**Kronospan**

Schedule 5 Response No 3

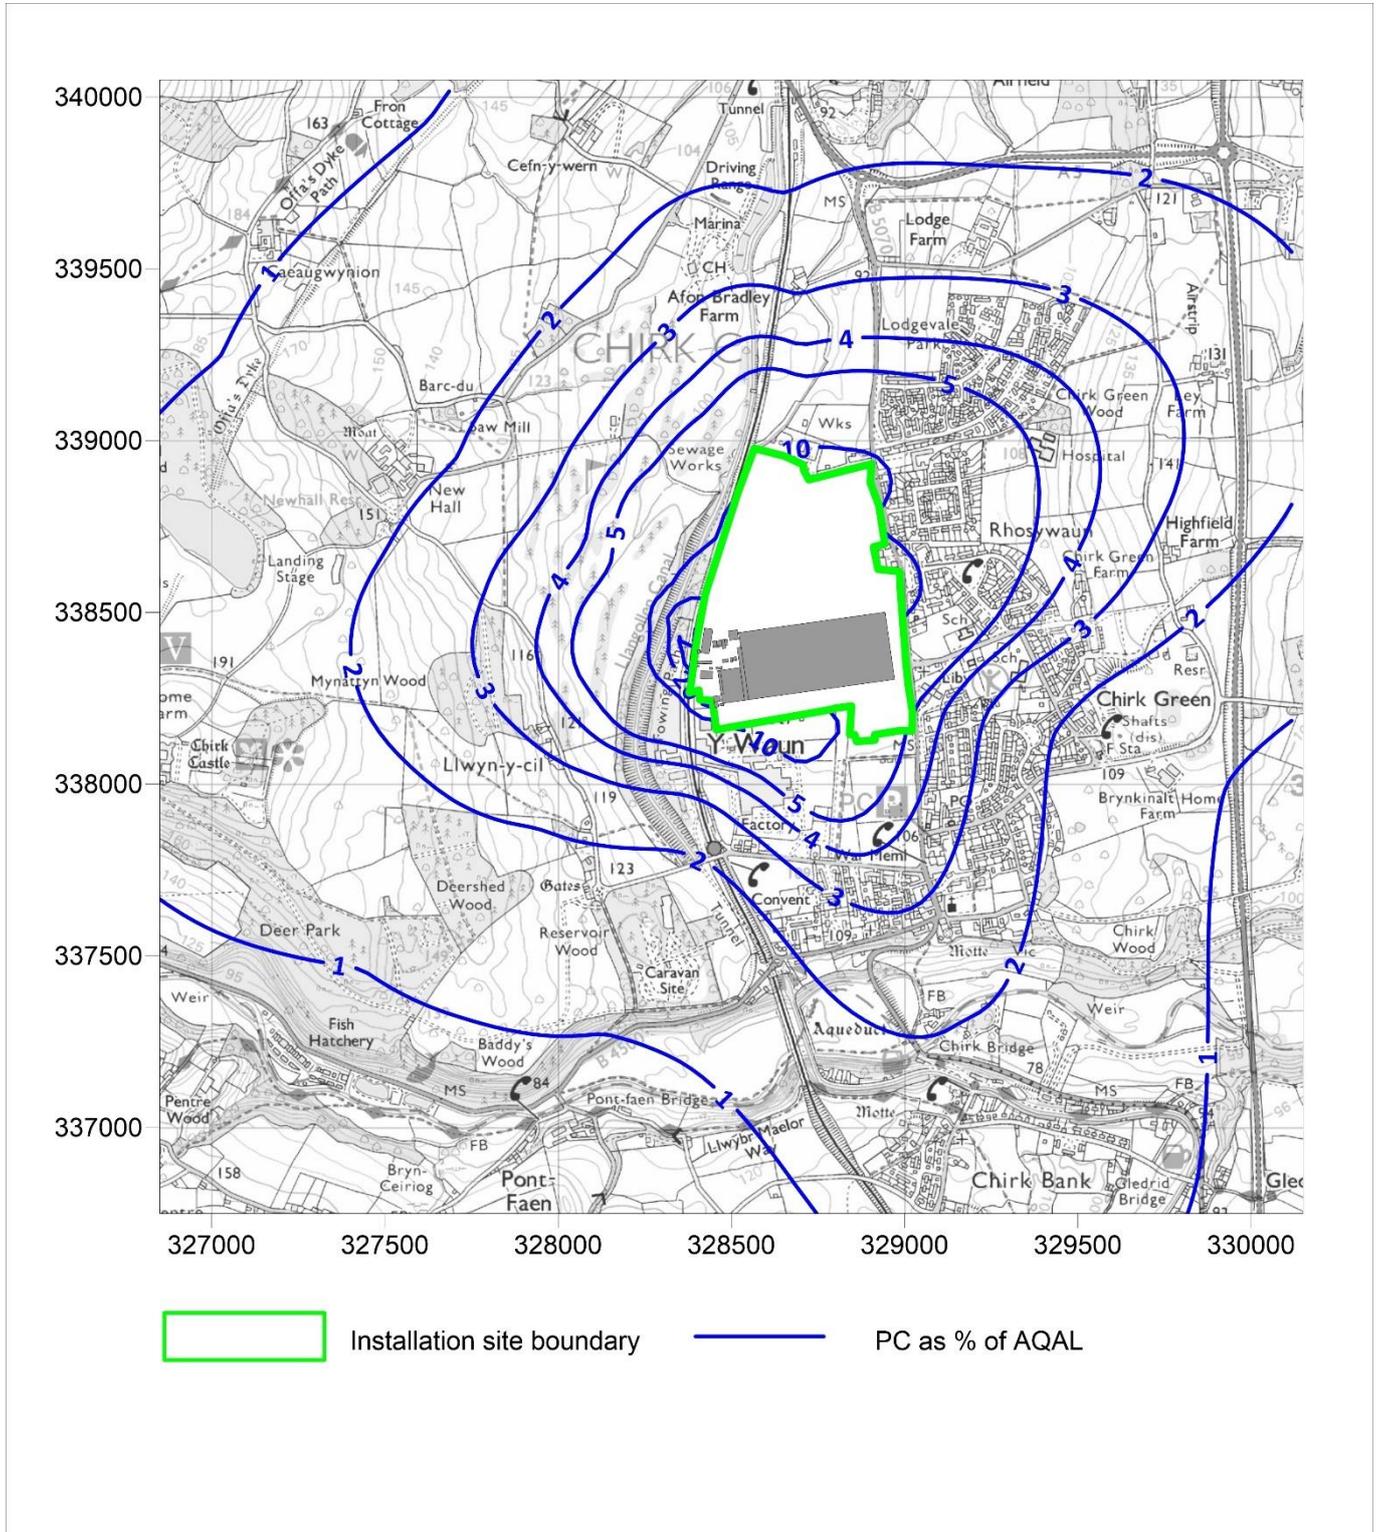
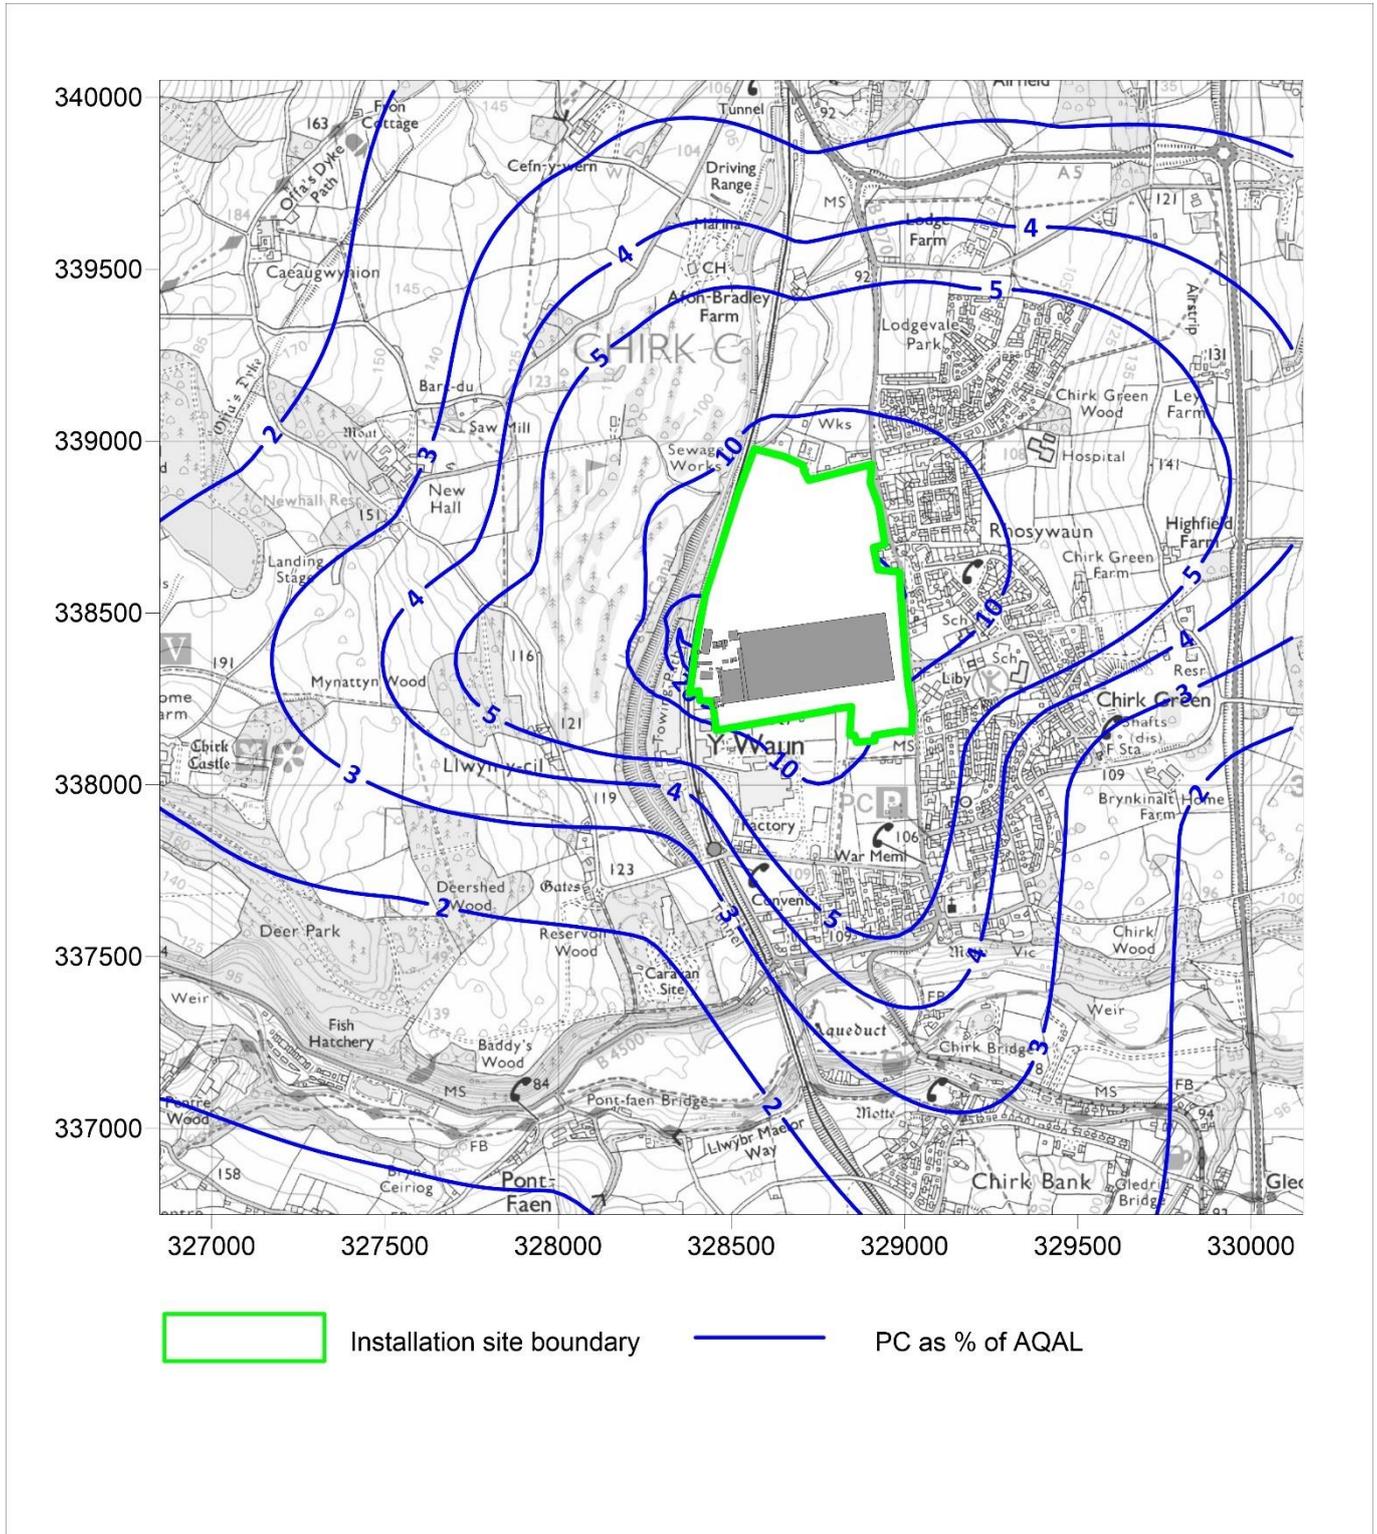
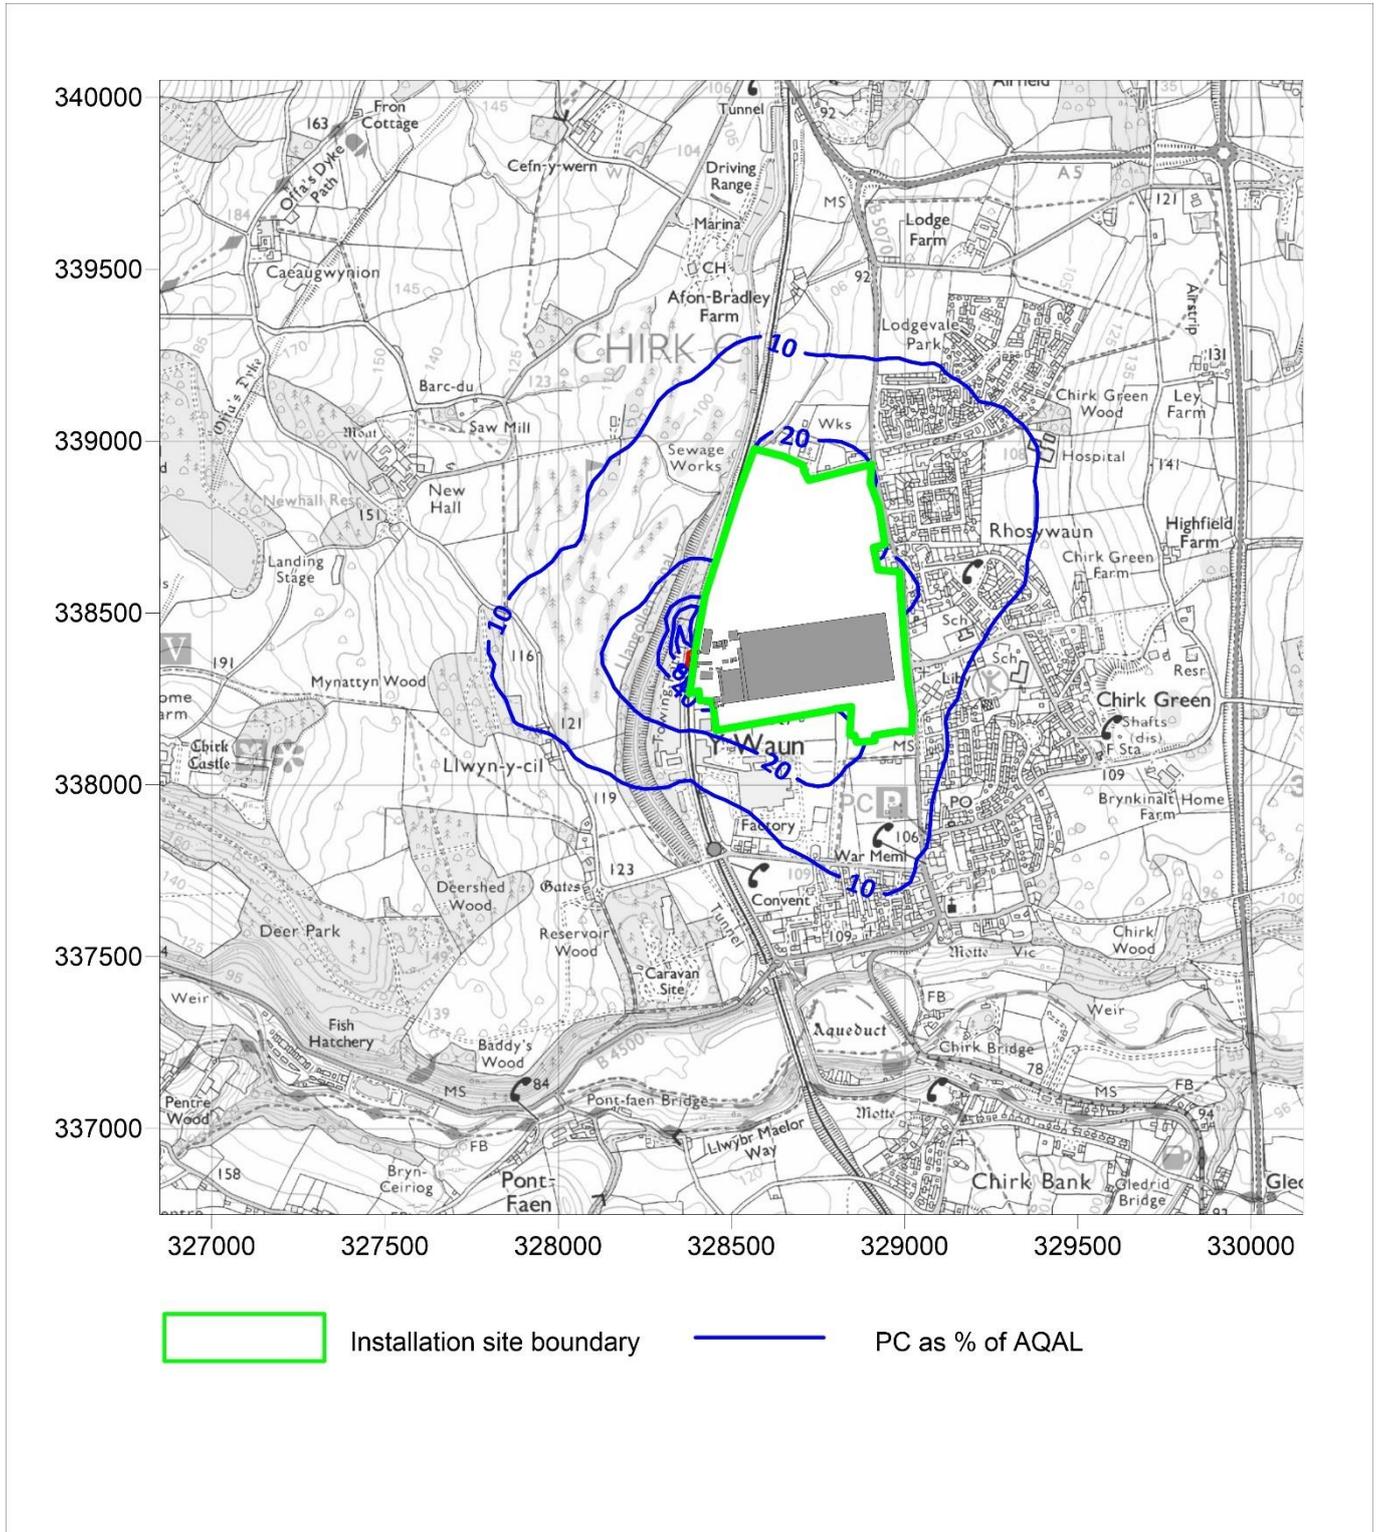
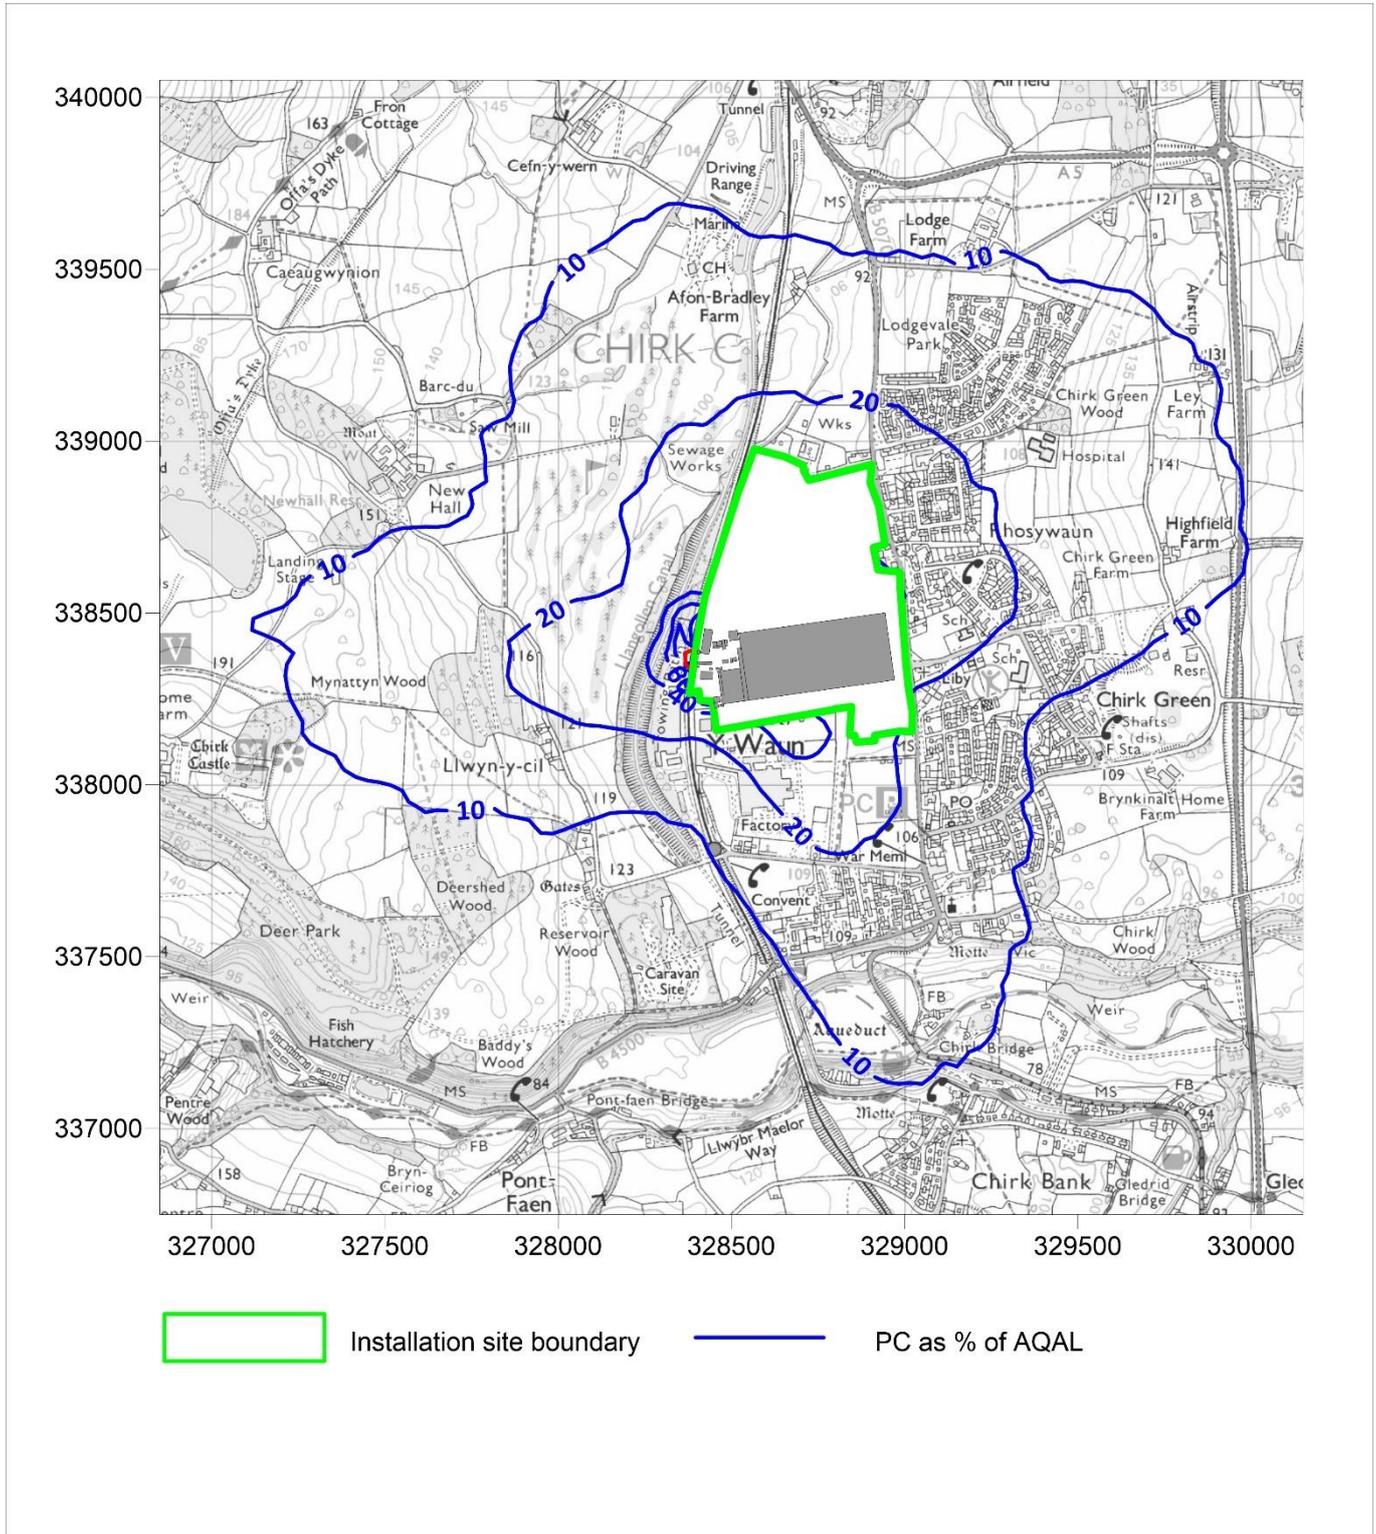
*As such, please confirm the number and location of the bag filter units on site, together with the process areas they serve. Please also update the air quality modelling files and associated assessment report to include releases from these items of plant. More specifically, the modelling for both the Likely and Worst Cases shall be updated to include the predicted impact of long and short-term releases from the bag filter plants. This shall be combined with the process contribution (PC) for other on-site sources of PM to give the overall PC associated with the entire site. This shall*

The dispersion plot files are presented in Appendix A, with the model input table for the additional sources provided in Appendix B. As shown at areas of relevant exposure the predicted impact does not exceed any AQAL. The predicted impacts are based on the following highly conservative assumptions:
